Service Category	Vehicle Exterior		
Section	Door/Hatch	Market USA	Scion Supports ASE Certification

YEAR(S)	MODEL(S)	ADDITIONAL INFORMATION	
2016	iA

Introduction

Figure 3.

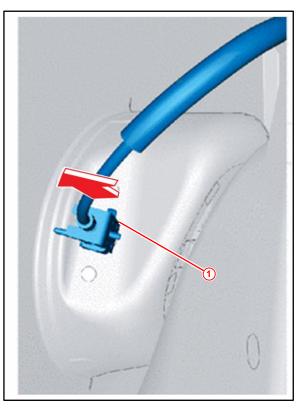
4. Detach ALL the stopper bracket tabs from the body and remove the stopper bracket.
